PG&E Letter DIL-03-011

Docket No. 72-26
Diablo Canyon Independent Spent Fuel Storage Installation
Response to NRC Request for Additional Information Regarding Cask Transporter
Lateral Restraints for the Diablo Canyon ISFSI (TAC No. L23399)

**PG&E Response to NRC Request for Additional Information
Regarding Cask Transporter Lateral Restraints
When the Transporter is Positioned Over the CTF**

SAFETY ANALYSIS REPORT
DIABLO CANYON ISFSI
FIGURE 5.1-1 (3 of 3)
OPERATION SEQUENCE FLOWCHART FOR
CASK SYSTEM LOADING, SEALING,
TESTING, AND STORAGE

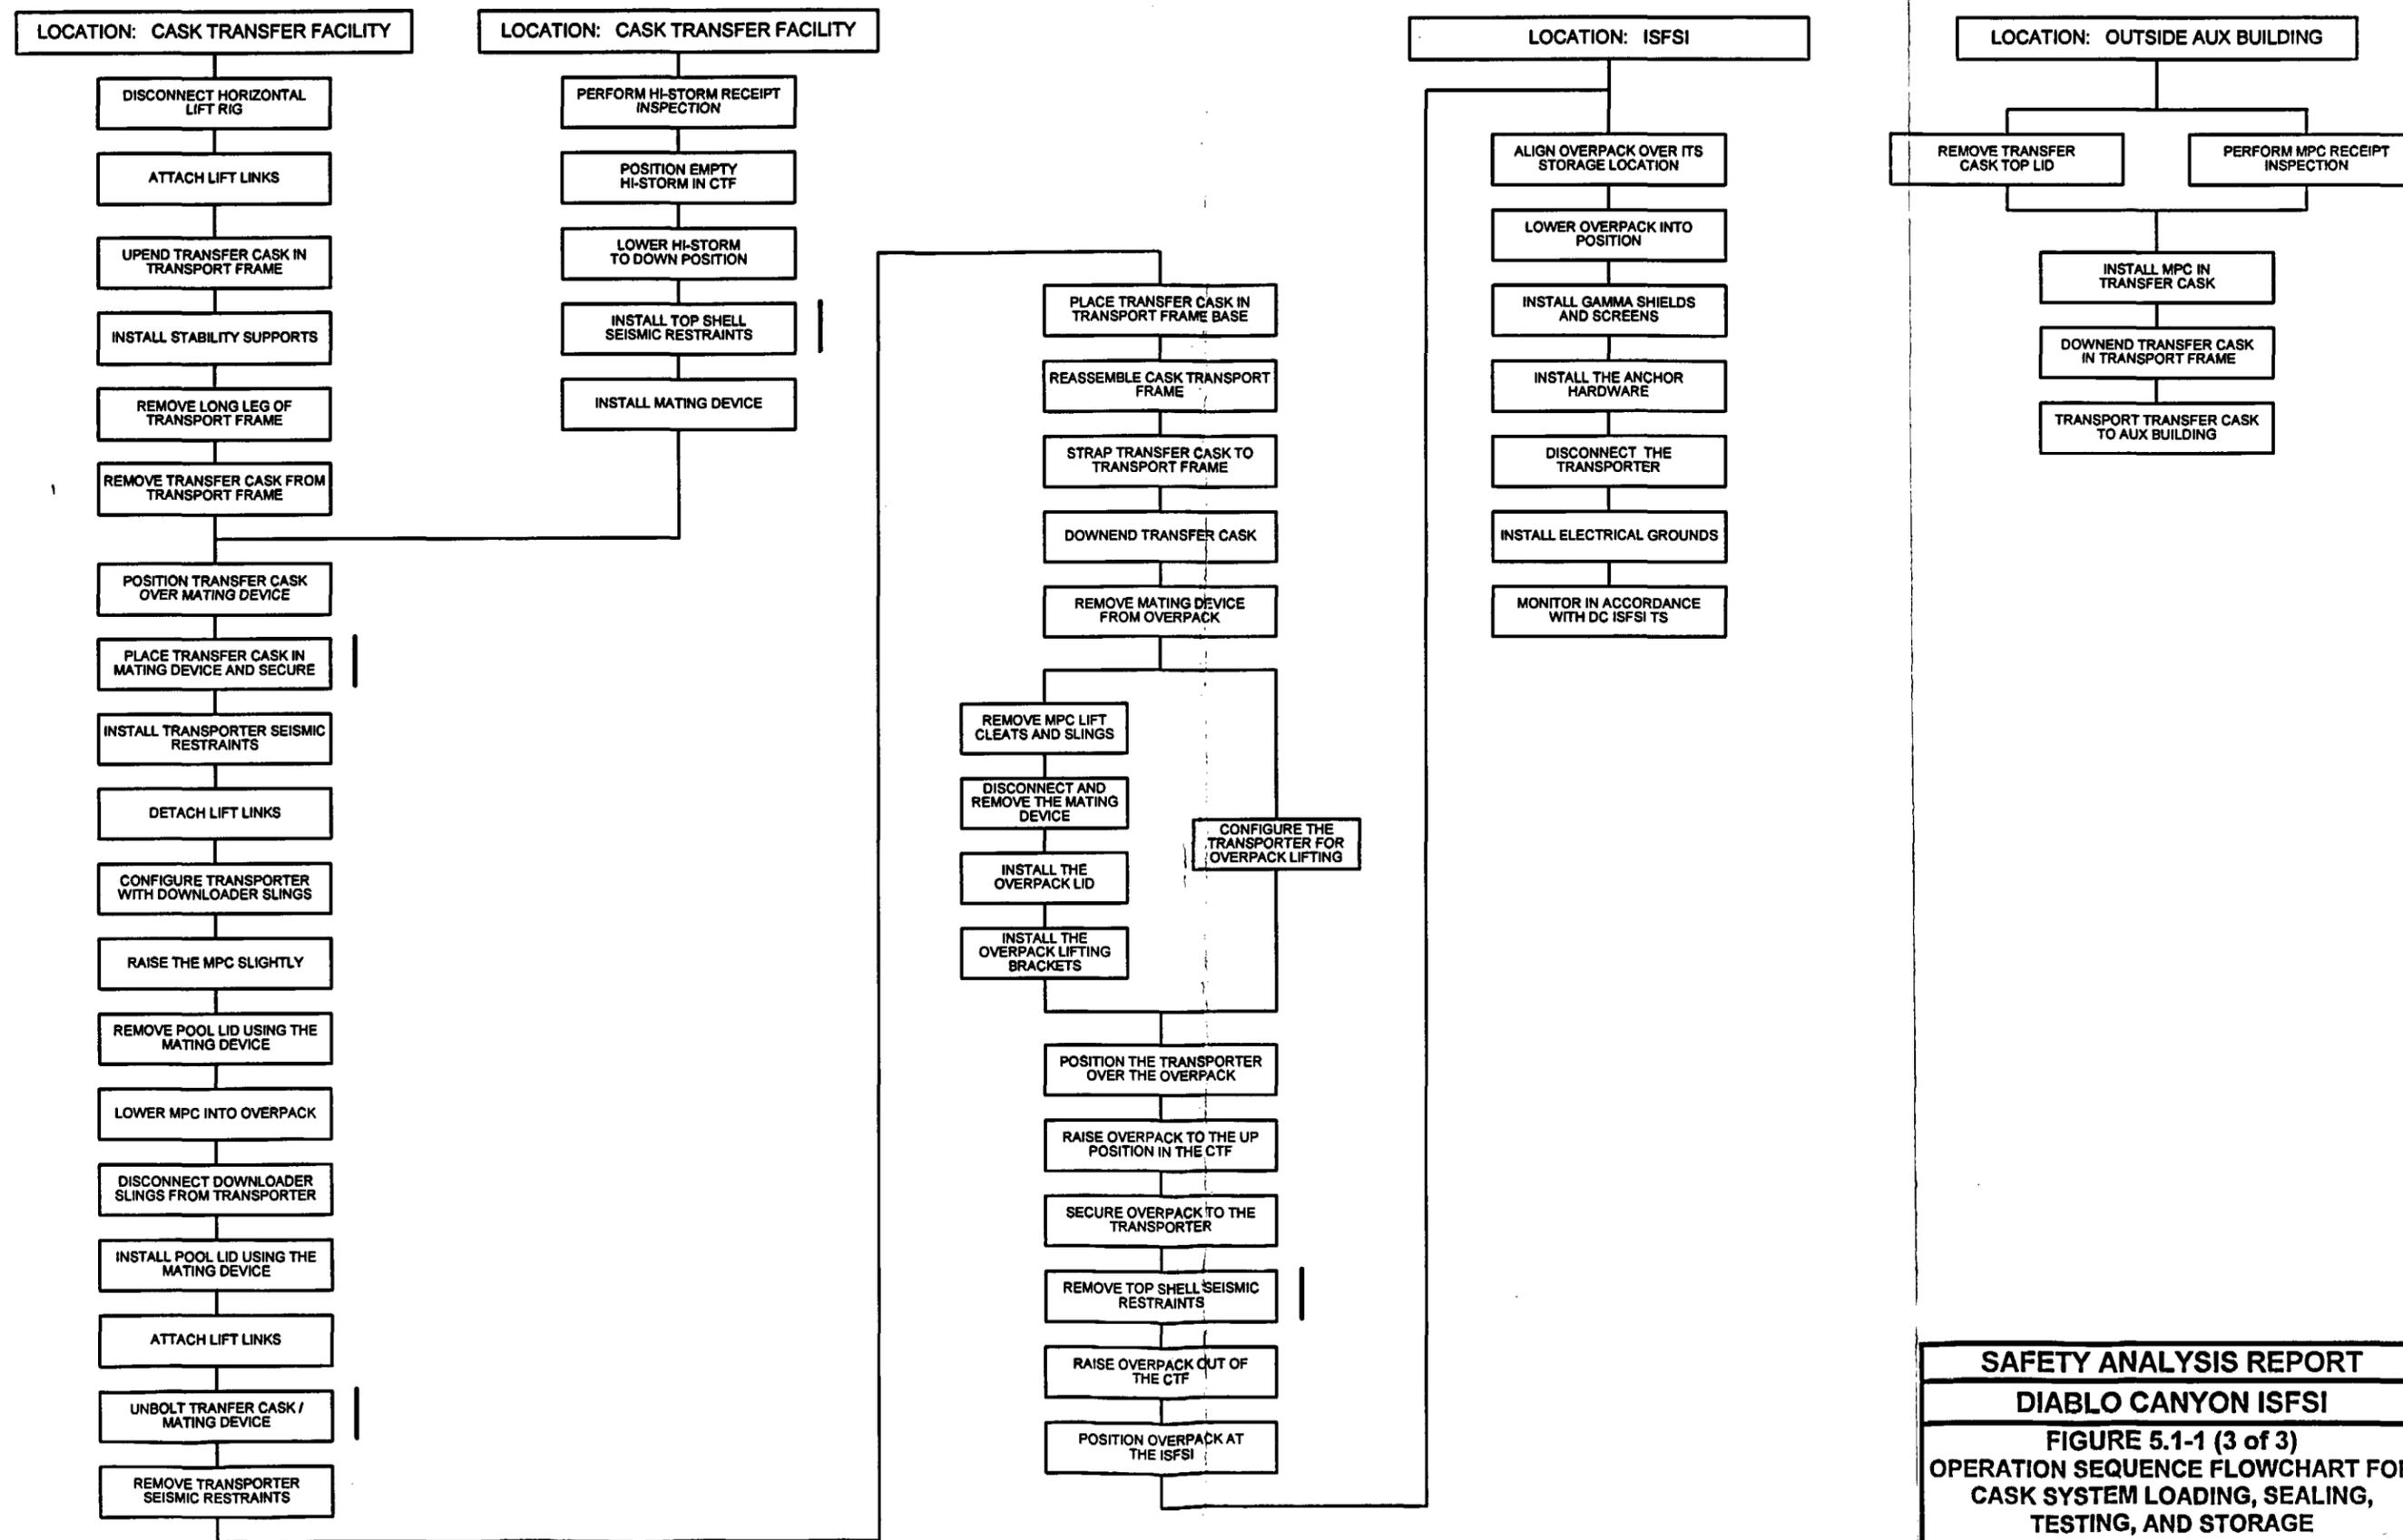
In a recent telephone call, PG&E staff indicated that the design of the cask transporter lateral restraints did not need to account for the weight of a loaded transfer cask, or loaded storage cask. For the specific configurations in question during MPC transfer at the CTF, PG&E indicated that the transporter is not relied upon to support these loads, except for very brief periods. The NRC staff requests that PG&E provide estimates of the brief time periods that the transporter is positioned over the CTF and is supporting: 1) the MPC as it is lowered into the overpack, and 2) the loaded HI-STORM 100 SA as it is raised off the CTF lift platform and out of the CTF. We understand that you consider the probability of an earthquake occurring while in either of these configurations to be so small as to make these events non-credible. This information is necessary for the staff to make its finding.

Revised Figures 5.1-1 (Sheet 3 of 3) and 5.1-2 (Sheet 1 of 2) are contained in Enclosure 2 with information added regarding the top shell seismic restraint installation and removal and the mating device. Also, in revised Figure 5.1-2 (1/2), under Cask Transfer Facility, the steps, "Remove Pool Lid Using the Mating Device," and "Connect Downloader Slings to Transporter," were reversed to show the correct order of these operations. Changes to the figures in Enclosure 2 are shown with side bars. PG&E will incorporate these figures into Amendment 2 of the FSAR, Section 5.1, which will be submitted to the NRC under separate cover. The revised figures will also be included in Section 5.1 of the ISFSI FSAR that will be submitted to the NRC within 90 days of the issuance of the ISFSI license.
